FRA-2004-18740-1

Date: June 4, 2004
DOT APP. NO. 913

This application is for removal of bridge locks from the top of the through span bridge structure and installation of new bridge locks on the bridge track deck. The new bridge locks will be monitored and interlocked with the signal system to assure the locks are within one inch of full insertion as required by FRA regulation 236.312.

EXHIBIT "A" U.P.R.R. Co. No.: **913** Docket No.: **DATE: 6/4/04**

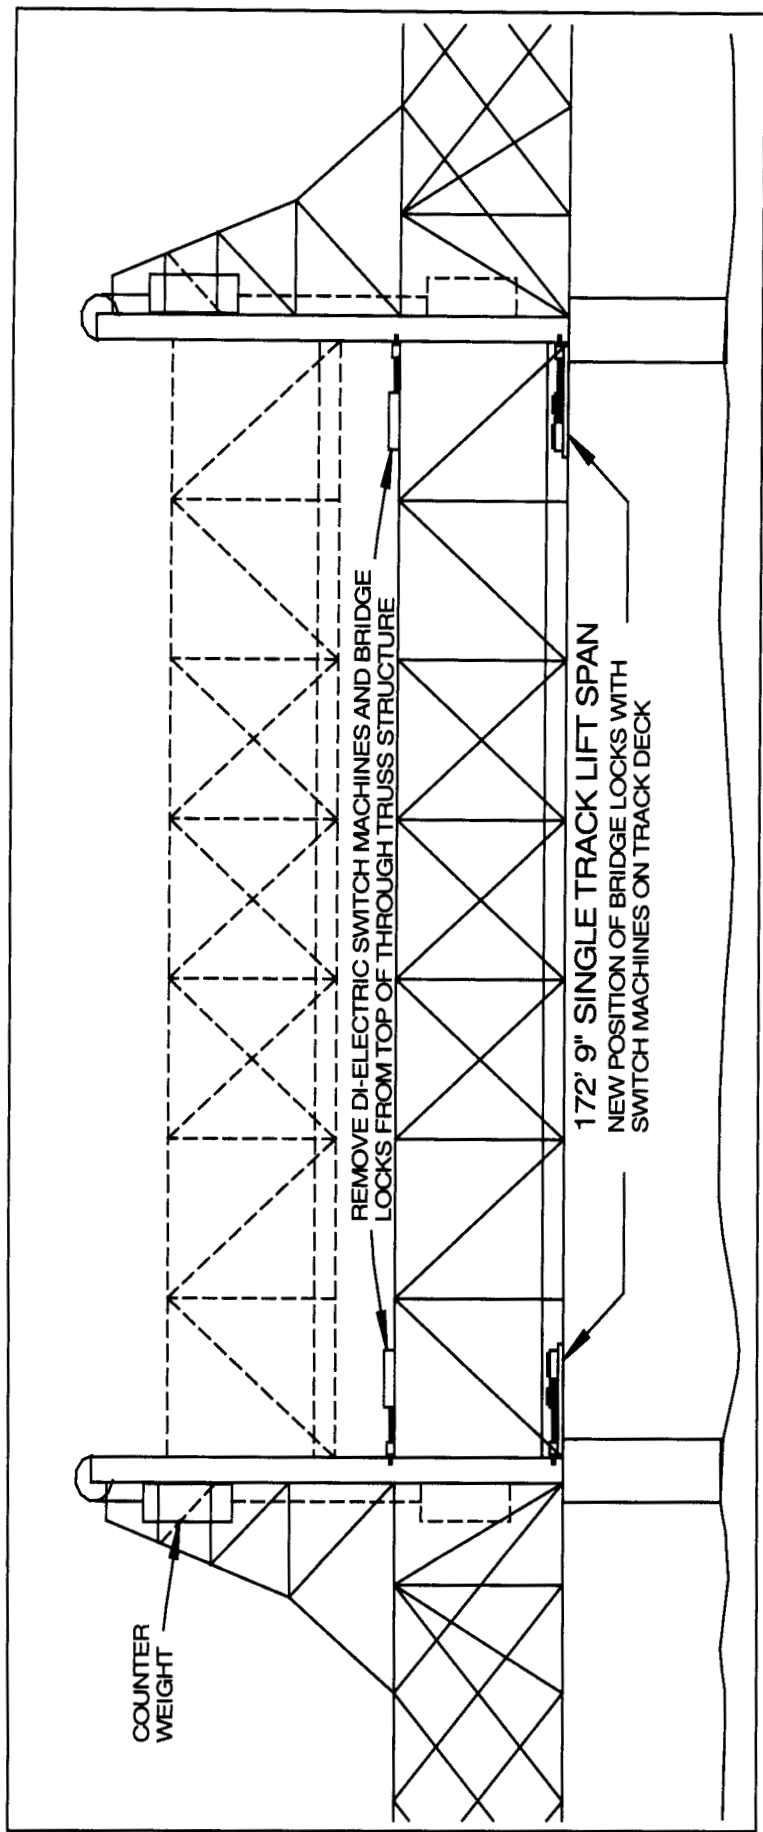
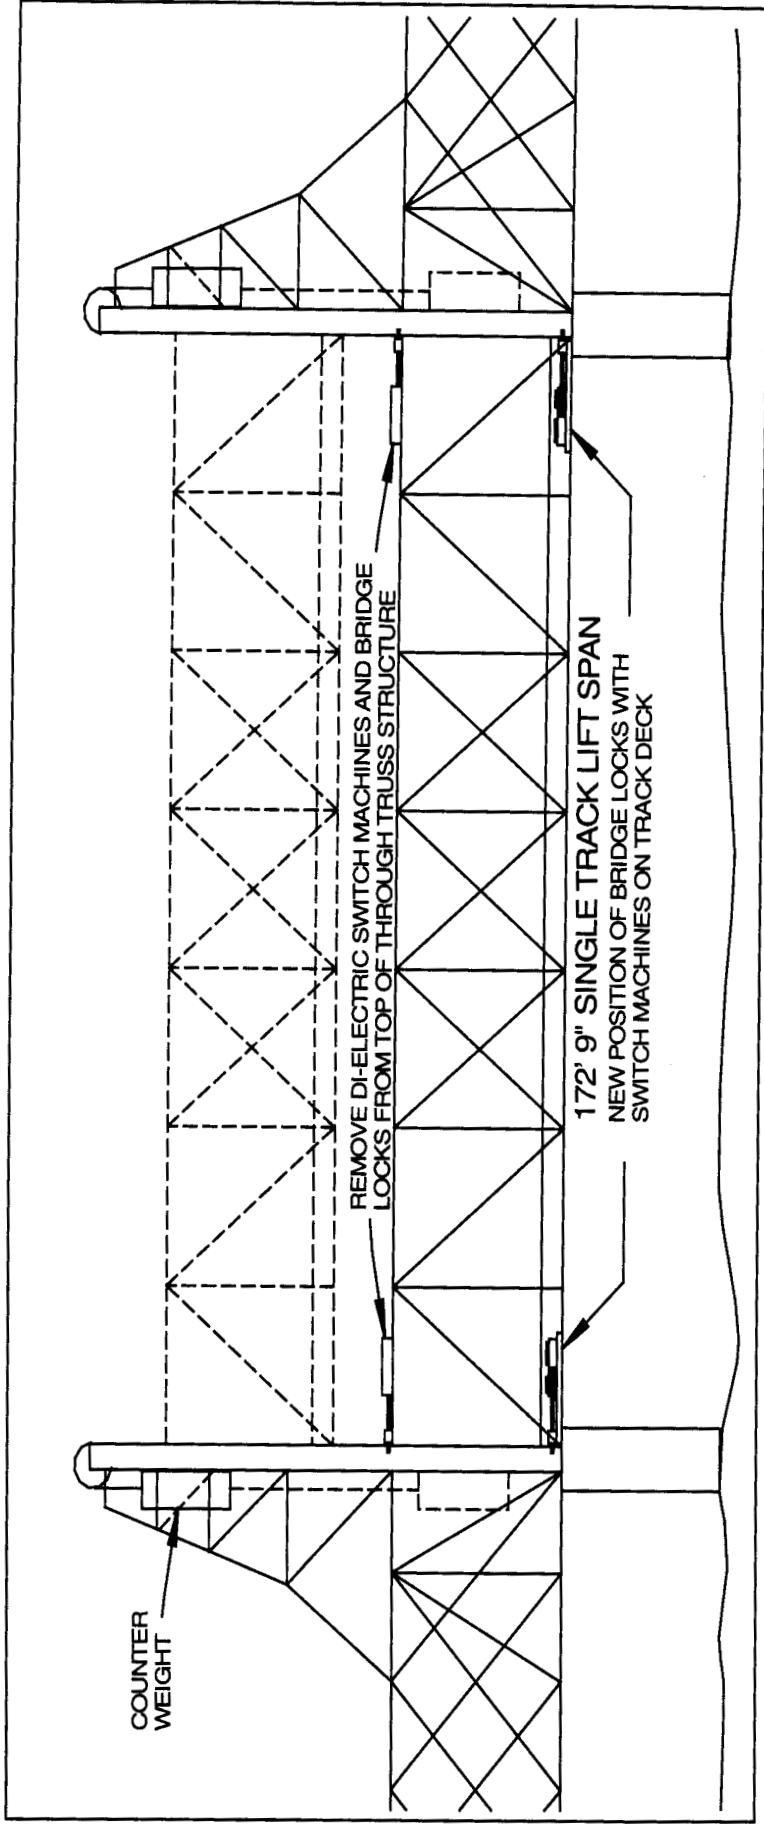
WORK TO BE DONE: Remove di-electric switch machines and bridge locks from top of through-truss bridge structure. Remove switch machine activated rail locks from each end of lower deck and reuse switch machines to activate new bridge locks installed on lower deck.

WORK TO BE DONE: Remove di-electric switch machines and bridge locks from top of through-truss bridge structure. Remove switch machine activated rail locks from each end of lower deck and reuse switch machines to activate new bridge locks installed on lower deck.
